SUBJECT: Transmittal of Westinghouse Responses to US NRC Requests for Additional Information on the AP1000 Application for Design Certification

AP1000 DESIGN CERTIFICATION REVIEW

RAI Number: 230.018 (Response Revision 3)

Table 3.7.2-2 (Sheet 2 of 2)

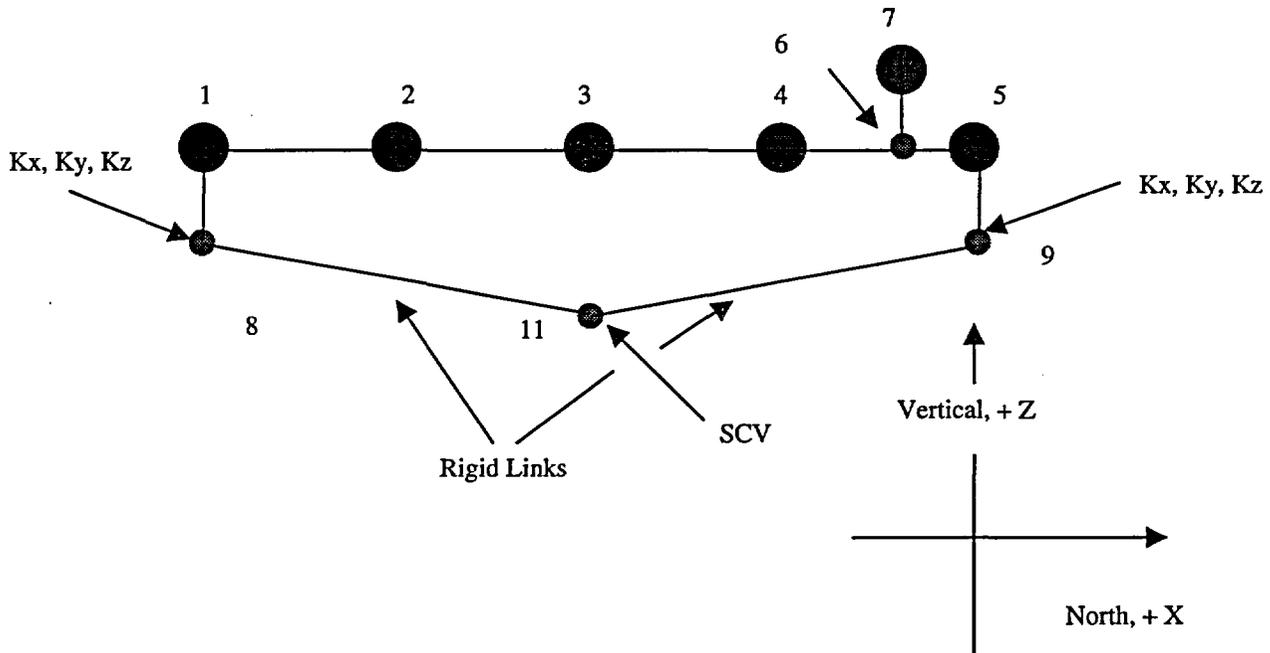
- B. As summarized in Table 3.7.2-5 of DCD, Revision 0, the comparison of the vertical seismic responses (maximum absolute nodal accelerations) of the two designs indicates that the dynamic amplification in the vertical direction is higher for the AP600 than for the AP1000. Based on our engineering judgement, it is the staff's expectation that the results should be reversed, because there is no change to the building wall thickness for both designs and the shield building complex of the AP1000 is more massive than that of the AP600. Westinghouse is requested to provide an explanation to address the staff's observation.

The staff's observation regarding the dynamic amplification discussed in (a) and (b) above are also applicable for the steel containment vessel.

Add sheet 2 to Table 3.7.2-2 showing modal properties of steel containment vessel combined with polar crane

In revision 1 to this response Westinghouse included Table 3.7.2-2 (sheet 2) in the DCD showing modal properties of the steel containment vessel combined with the polar crane.

Figure 230.018-1

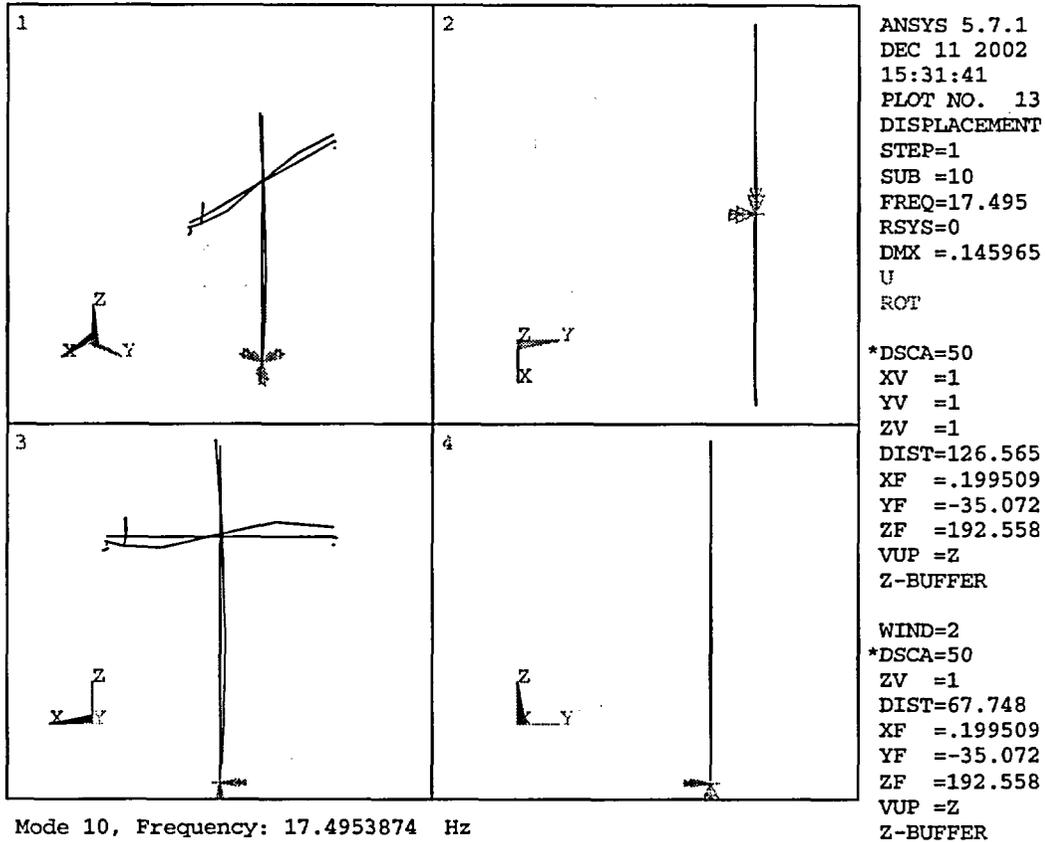
The staff also requested a similar clarification for the vertical dynamic amplification for the steel containment vessel. In its response, Westinghouse indicated that the vertical acceleration response of the steel containment vessel, 1.49g for AP600 and 1.40g for the AP1000 and the comparison is similar to that for the vertical response of the shield building roof. However, in the most recent AP1000 analyses in the proposed revision to DCD Section 3.7, the maximum vertical acceleration response is significantly reduced to 1.13g. Westinghouse attributed such reduction in the vertical response to the use of a multi-mass model for the polar crane instead of the single-mass model used in both the AP600 and the initial AP1000 analyses. To incorporate the change from the single-mass to multi-mass model of the polar crane, Westinghouse proposed the following revisions to the AP1000 DCD:

The proposed DCD revisions sufficiently described the multi-mass polar crane model, but did not provide a sufficient basis for the significantly reduced vertical acceleration of 1.13g for the steel containment vessel. Westinghouse agreed to provide additional justification regarding the reduction of the vertical acceleration by using the new polar crane model.

Table 230.18-1 shows the significant modes from these tables contributing to the vertical response as well as the corresponding data for the containment vessel with a one mass model of the polar crane used in the previous AP1000 analyses documented in DCD Rev 1. The table includes results for a concentric stick model of the nuclear island, which includes a one mass model of the polar crane with the same local shell flexibility as that in the multi mass model. The table also shows the maximum vertical acceleration of the containment vessel at the top of the dome and at the crane girder from analyses of the combined nuclear island stick models. The single mass polar crane models show larger vertical accelerations than the multi mass model. The polar crane multi mass model introduces a mode (at 17.495 Hz) with coupling between the vertical and horizontal responses. The shape of this mode is shown in Figure 230.18-1. It is a rotational mode of the polar crane and containment vessel with coupling between the horizontal and vertical directions. This additional mode accounts for the reduction in vertical response.

In revision 2 to this response Westinghouse included Table 230.18-1 and Figure 230.18-1 showing the additional rotational mode of the multi mass polar crane and containment.

Figure 3.7.2-18

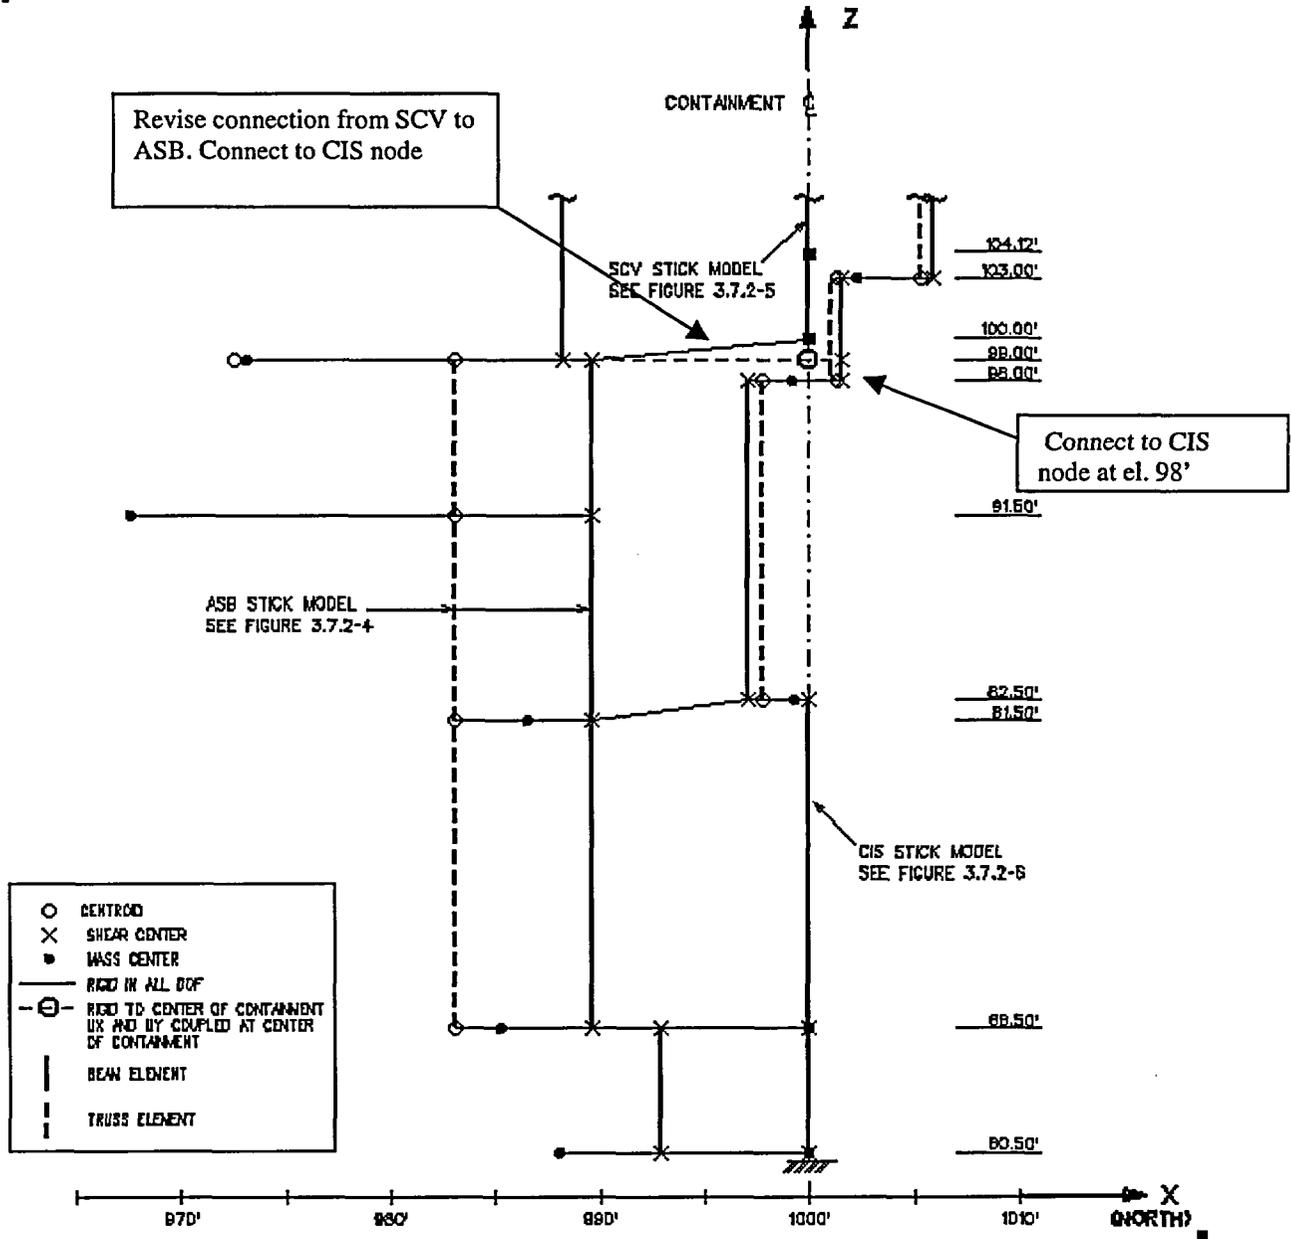
The interaction between the steel containment vessel and the rest of the nuclear island was investigated. As shown in Table 230.18-1 the steel vessel and polar crane have significant frequencies at 16.37 Hz and 27.34 Hz. The nuclear island stick model has significant vertical frequencies at about 16 Hz (see DCD Table 3.7.2-4) and between 25 and 30 Hz. The vertical modes of the auxiliary and shield building in the nuclear island stick analyses were found to be reducing the response of the containment vessel at the polar crane elevation and amplifying the response of the top of the containment vessel. The containment vessel stick model is attached by a rigid link to the auxiliary and shield building stick at elevation 99' as shown in DCD Figure 3.7.2-18. At this elevation the centroid of the auxiliary and shield building cross section is far from the center of the containment vessel and rotation of the auxiliary and shield building stick affects the containment vessel vertical response. The structural configuration is shown in DCD Figure 3.7.2-12, sheet 9. Due to flexibility of the slab in the annulus at elevation 100', it was also recognized that the vertical displacement of the containment vessel would be controlled primarily by the containment internal structures and the cradle rather than by the shield building.

- Revise the connection at the base of the steel containment vessel stick in the nuclear island analyses. The base of the stick will be connected to the containment internal structure node at elevation 98' instead of to the auxiliary and shield building stick.
- Revise the truss elements at the lower elevations of the auxiliary and shield building model. This reduces their eccentricity and slightly improves the matching of the stick model modal properties to those of the finite element shell model. This change is conservative since it increases the vertical response of the auxiliary and shield building above that predicted in the dynamic analyses of the shell model.
- Develop floor response spectra using the more accurate post-processor instead of the standard ANSYS post-processor.

Revise Figure 3.7.2-18.
